RE: WINDACTION-SHEA JOINT MOTION TO AMEND PUC ORDER OF JUNE 26, 2020

Amended Petition of Deerfield Wind, LLC, for a certificate of public good authorizing the construction and operation of a 15-turbine (30 MW) wind generation facility, and associated transmission and interconnection facilities, on approximately 80 acres in the Green Mountain National Forest, located in Searsburg and Readsboro, Vermont, with 7 turbines placed on the east side of Route 8 (Eastern Project Area), and 8 turbines along the ridgeline to the west of Route 8 (Western Project Area).	PUC Docket N. 7250
---	--------------------

WINDACTION-SHEA MOTION TO AMEND
THE VERMONT PUC ORDER OF JUNE 26, 2020

**WINDACTION-SHEA JOINT COMMENTS IN RESPONSE TO
VERMONT PUC ORDER OF FEBRUARY 12, 2020**

Source: <https://en.wind-turbine-models.com/powercurves>

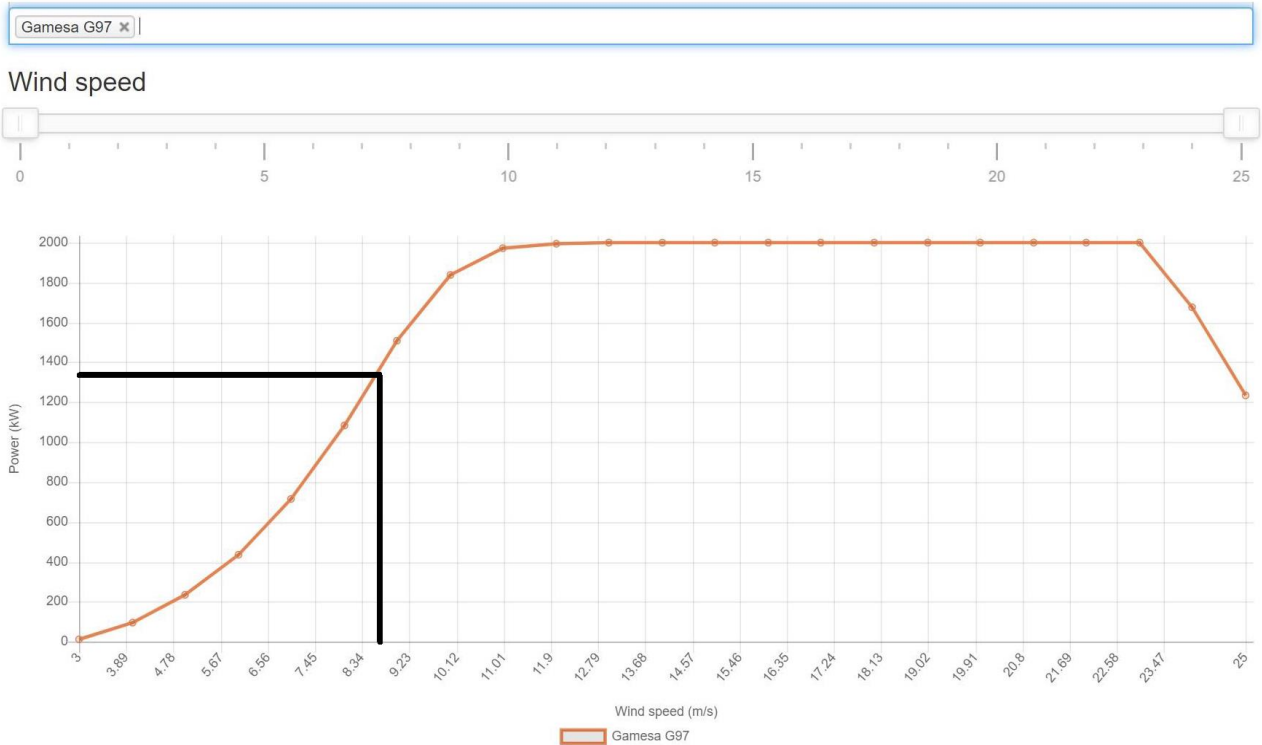
Mr. Kaliski’s figures further confirm that the Department’s strict adherence to the 6 m/s threshold is incorrect. The manufacturer’s power curve for the Gamesa G97 turbines (below) shows the G97 does not achieve 67% of full electric output (1,350± kW) until hub height wind speeds reach nearly 9 m/s.
